Sapphire Wind Farm - Modification No. 1

MP/09_0093

Sapphire Wind Farm - Modification No. 1

Figure 1: Approved Project Layouts with areas highlighted for wind turbine removal

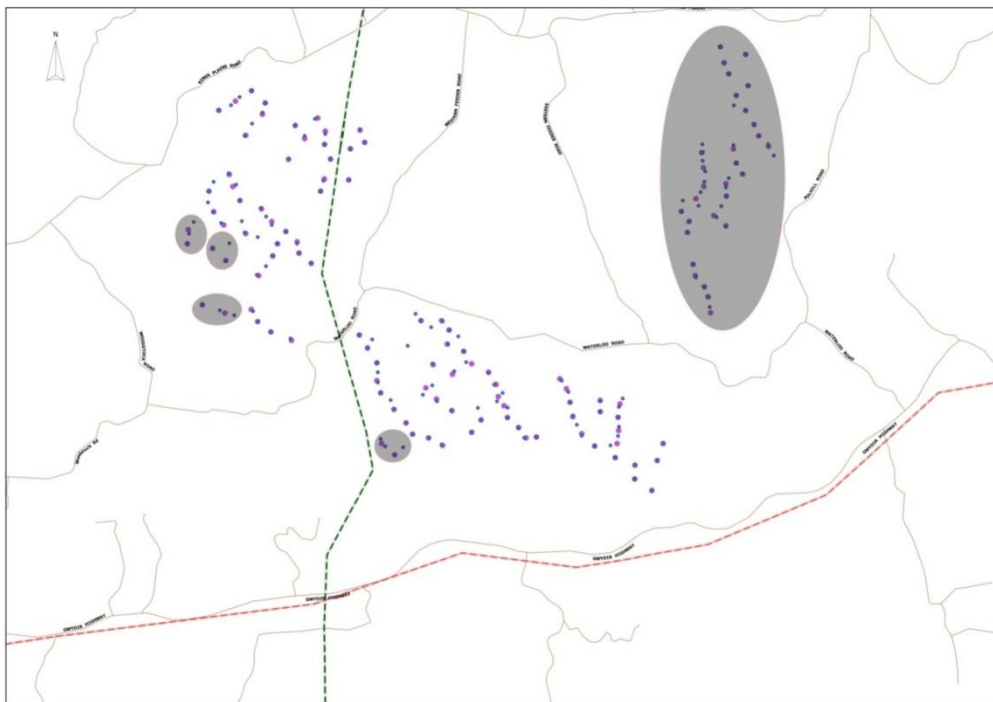
The modified Project will comprise of up to 109 wind turbine generator locations from the approved 159 wind turbine layout (previously referred to as Layout 1). This reduction is from five key areas of the Project, but most notably involves the removal of the Wellingrove cluster in its entirety (Figure 1).

Figure 2: Proposed Modified Single Project Layout

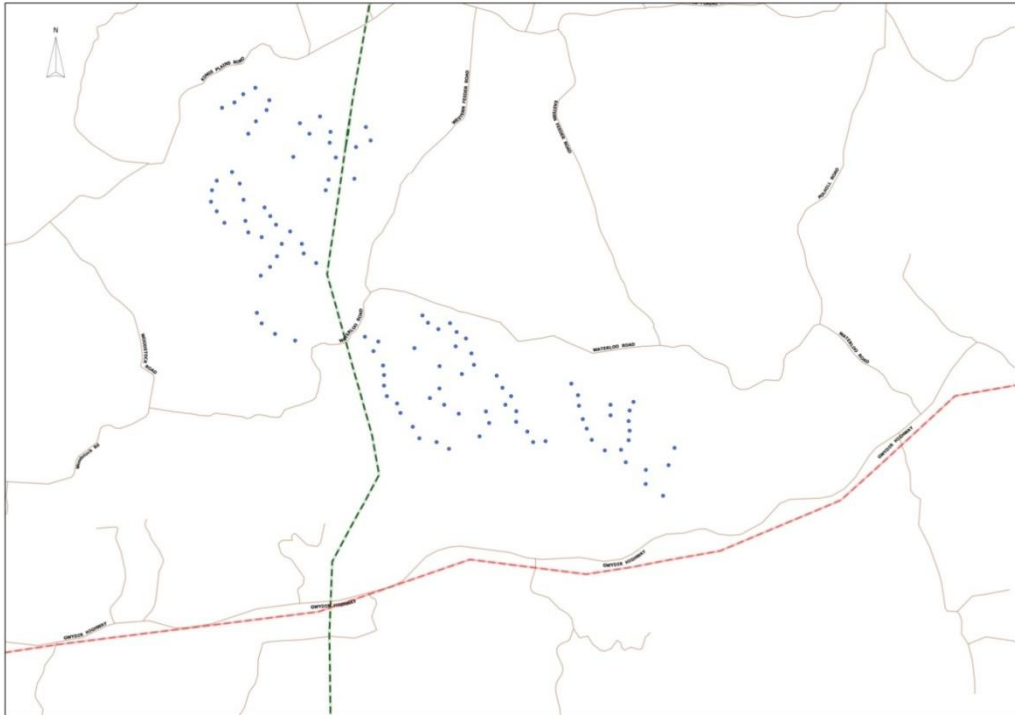
Figure 2 depicts the revised 'single-layout' Project which has been presented to provide greater certainty for all Project stakeholders.

Figure 8: Areas of Layout Micrositing (An A3 version is included in Appendix A)

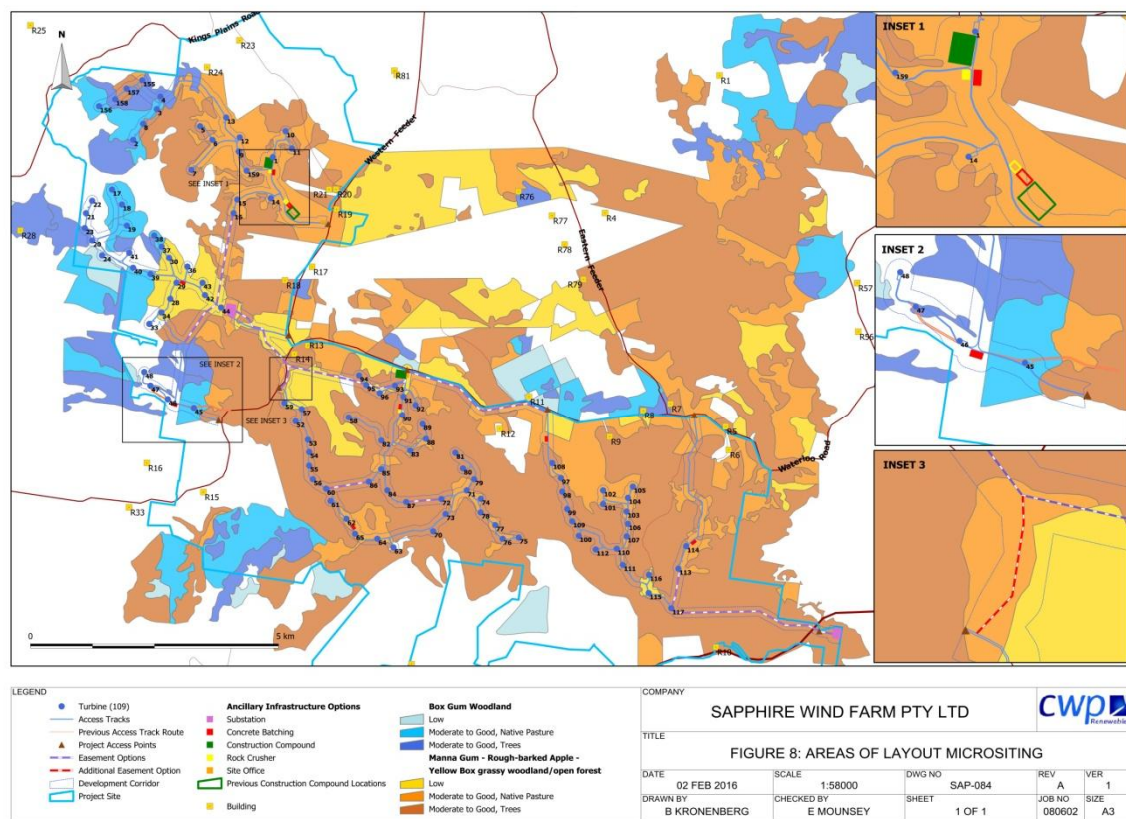
In addition to the wind turbine generator amendments detailed above, this modification also deals with some minor changes to the on ground road and electrical design. These changes are depicted in Figure 8 with the associated impacts considered in the ecology and heritage reports attached to this modification. (Note that these changes to the on ground road and electrical design have been included in Figures 3 to 7 above).

Figure 9: Removal of nine wind turbine locations near the "Krystal Blue" dwelling

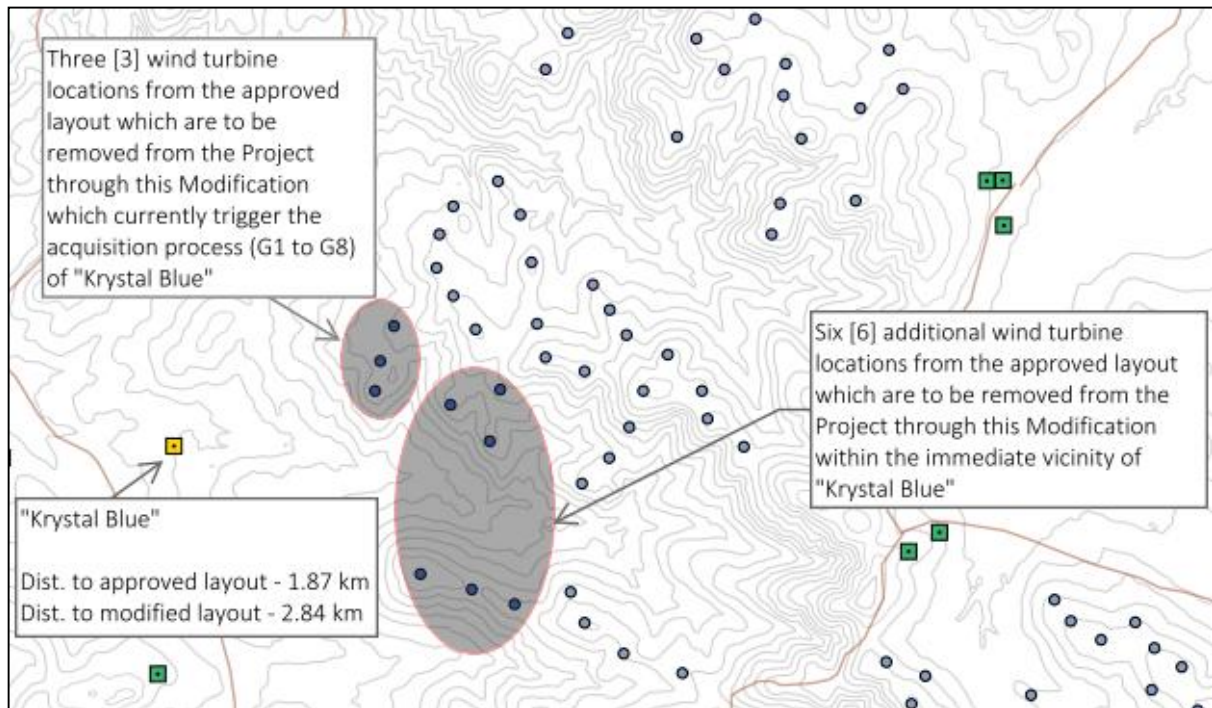
An additional Neighbour Agreement with "Krystal Blue" may also be sought. This will be subject to the Department's consideration of current Conditions of Consent G1 to G8 having regard to the removal of nine potential wind turbine locations from the immediate area of the dwelling (Figure 9). The removal of these nine potential wind turbine locations includes up to three locations which are currently referenced in G1 which would have otherwise triggered an acquisition process.
